RIVERSIDE COUNTY FIRE DEPARTMENT

Re: CPV SENTINEL ENERGY PROJECT (07-AFC-3)

With respect to the Preliminary Staff Assessment regarding the CPV Sentinel Energy Project, I would like to offer the following:

CPV SENTINEL ENERGY PROJECT

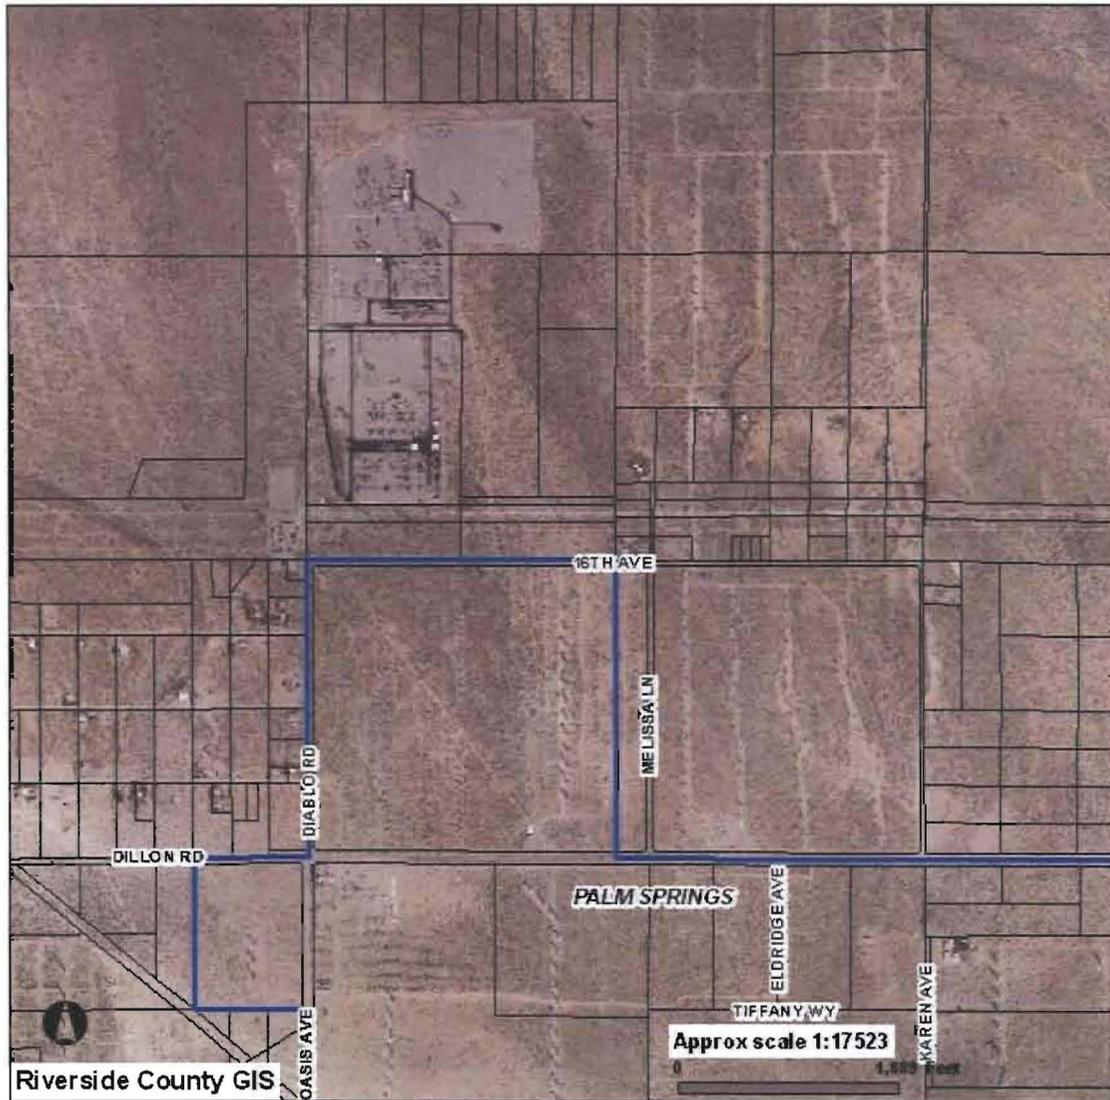
The Project Description 3-1 states that the plant will be situated within unincorporated Riverside County and adjacent to City of Palm Springs northern city limits. According to Figure 2, the Local Setting will in fact be located within unincorporated Riverside County. Therefore, the Worker Safety and Fire Protection 4.14-3 would require amending.

The proposed facility would be located within Riverside County Fire Department jurisdiction and not Palm Springs Fire Department (PSFD). Fire Department services, impacts and mitigation will also be impacted by this jurisdictional error and require further assessment.
